CASE SUMMARY SHEET

CASE NUMBER: V24-05-17/R24-05-02

Address: 201 Dalwill

REQUEST: V24-05-17/R24-05-02 – Jordan Williams requests a variance to CLURO Section 5.2.3.4. Remainder of the City and Section 7.5.9.3. B-2 Site Development Regulations, Dalwill Drive, Section 33 Lot OP1-2-B, B-2 Highway Business District, 201 Dalwill Drive

CONCEPTUAL SITE PLAN

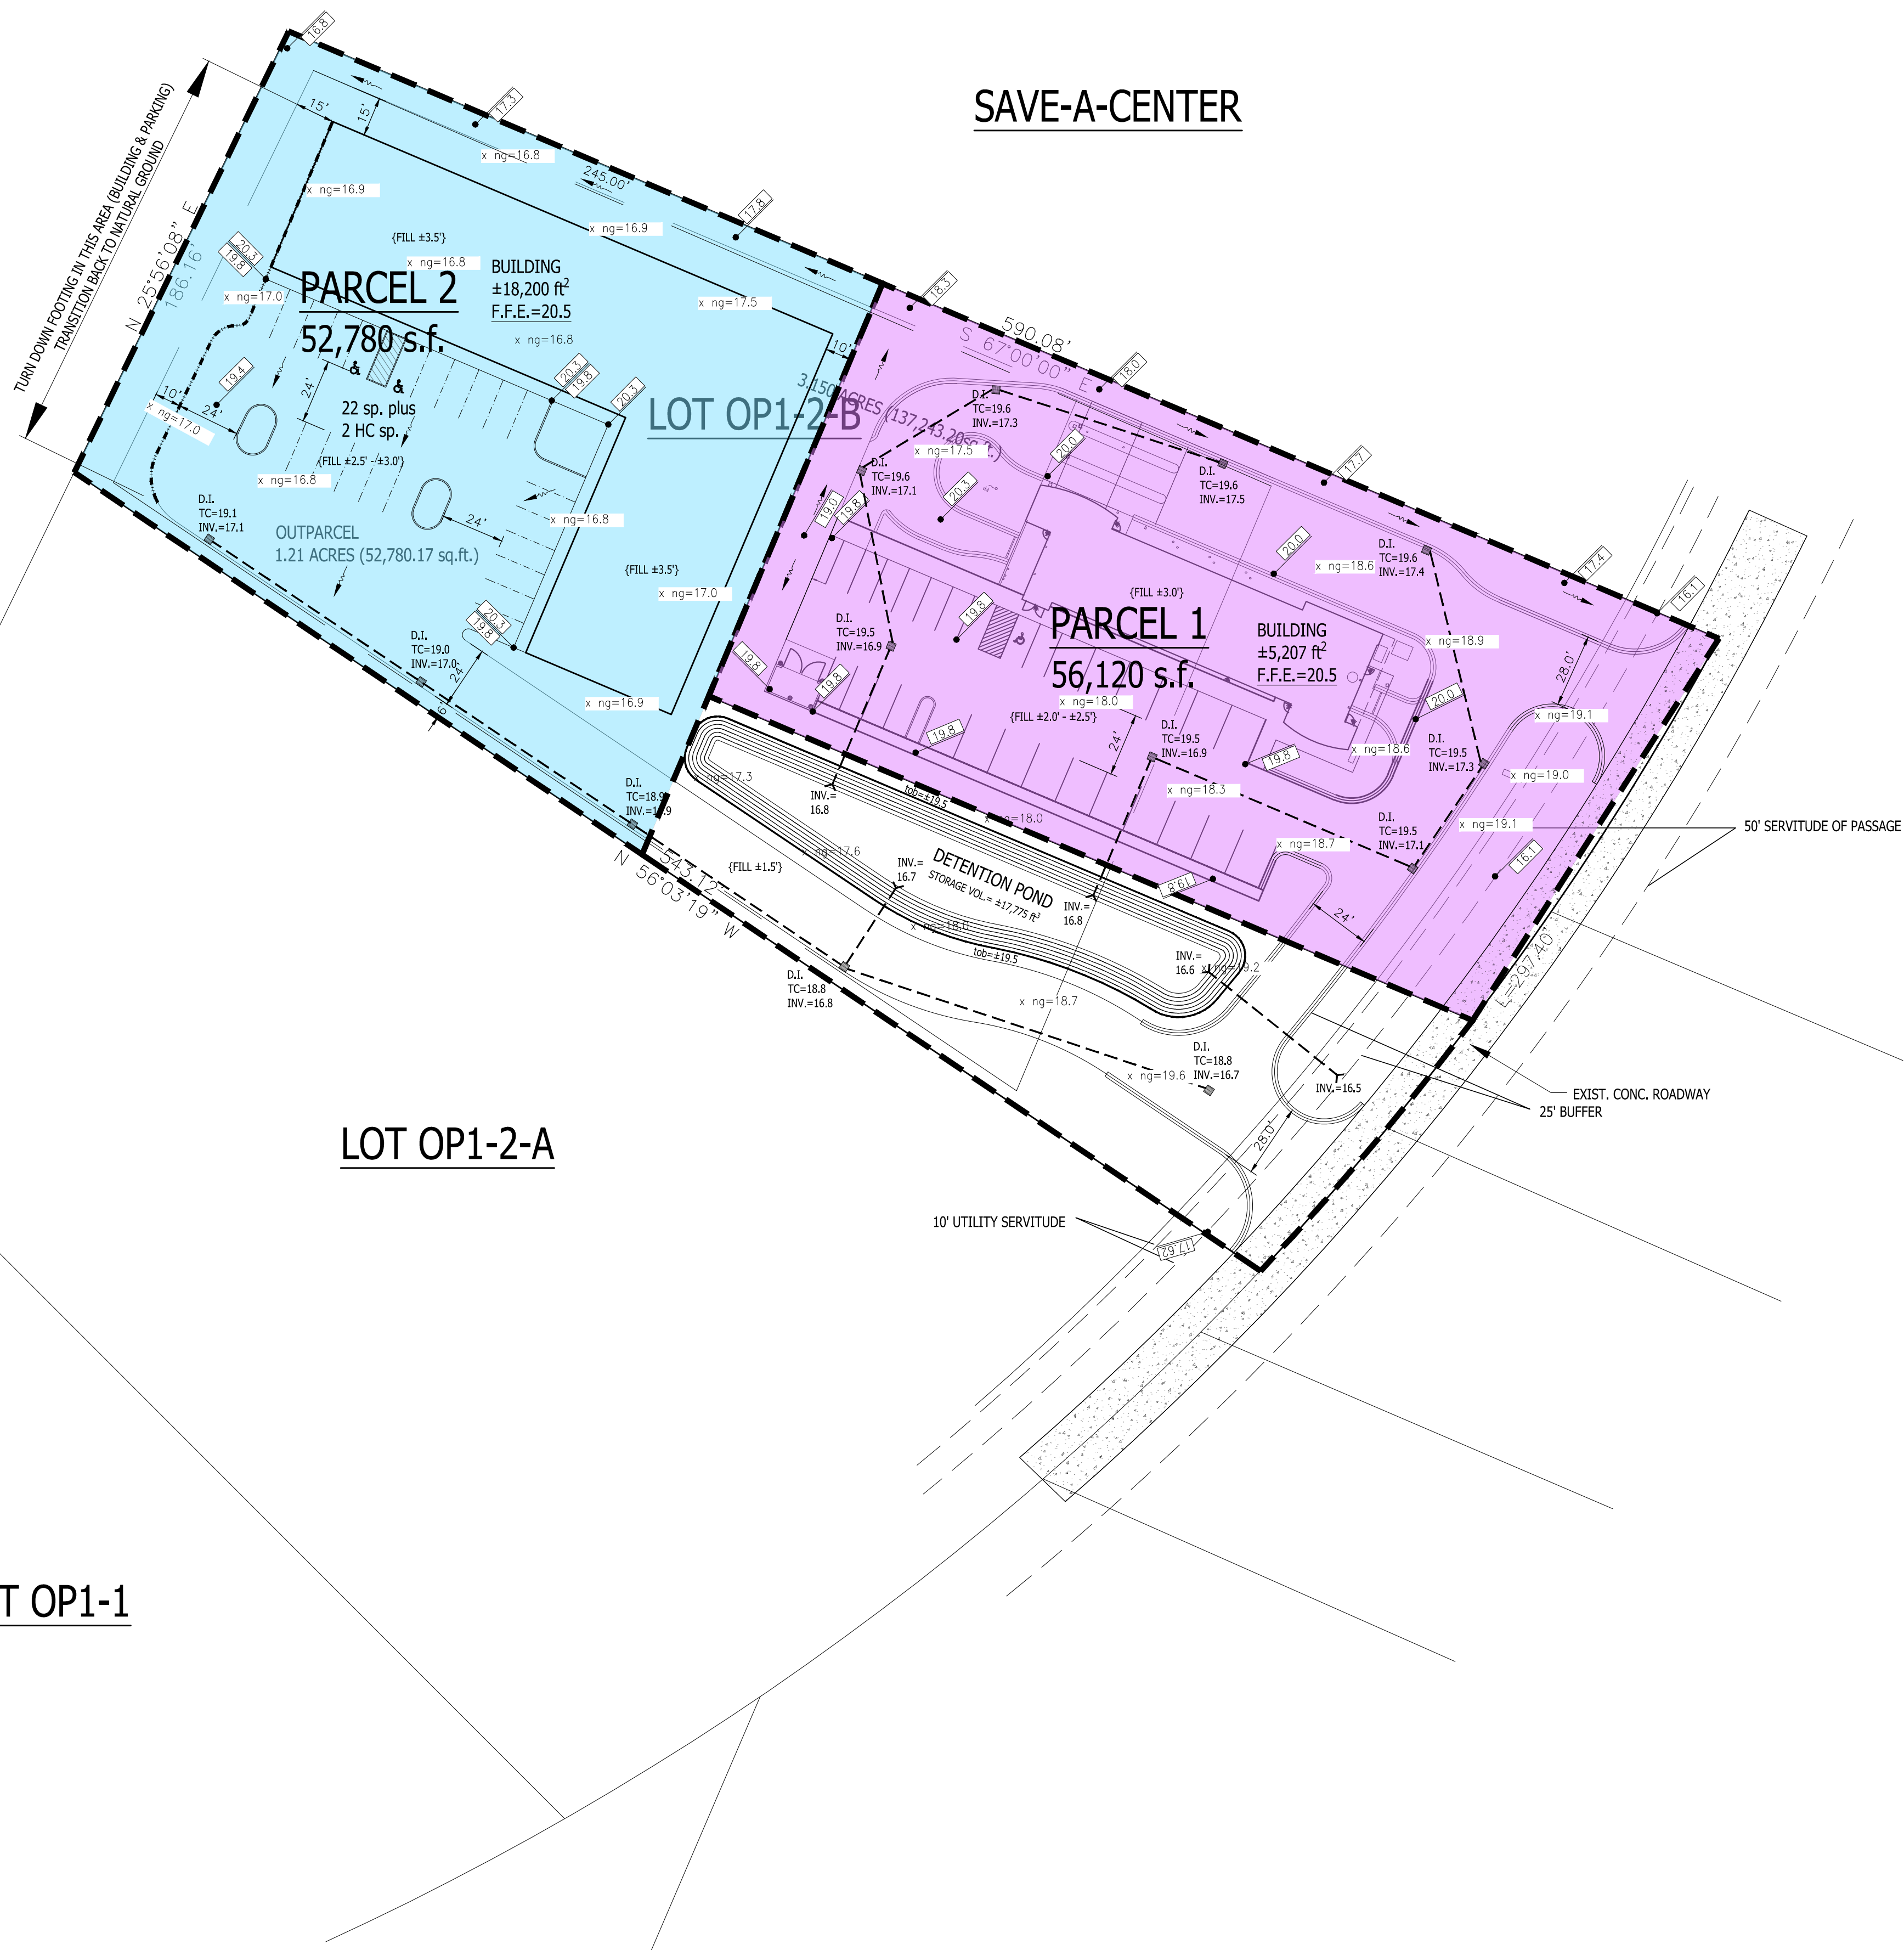
The City Engineer reviewed the submitted plans and had the following comments: The proposed elevations for Lot OP1-2-B are consistent with fill allowed on the adjacent lot (Lot OP1-2-A) to the south; and consistent with the elevations of Rouses parking lot to the north. In addition, the plans show a stormwater detention pond on site to mitigate runoff from the site.

I have reviewed the reviewed the fill variance request for 201 Dalwill Drive. The proposed elevations for Lot OP1-2-B are consistent with fill allowed on the adjacent lot (Lot OP1-2-A) to the south; and consistent with the elevations of Rouses parking lot to the north. In addition, the plans show a stormwater detention pond on site to mitigate runoff from the site.
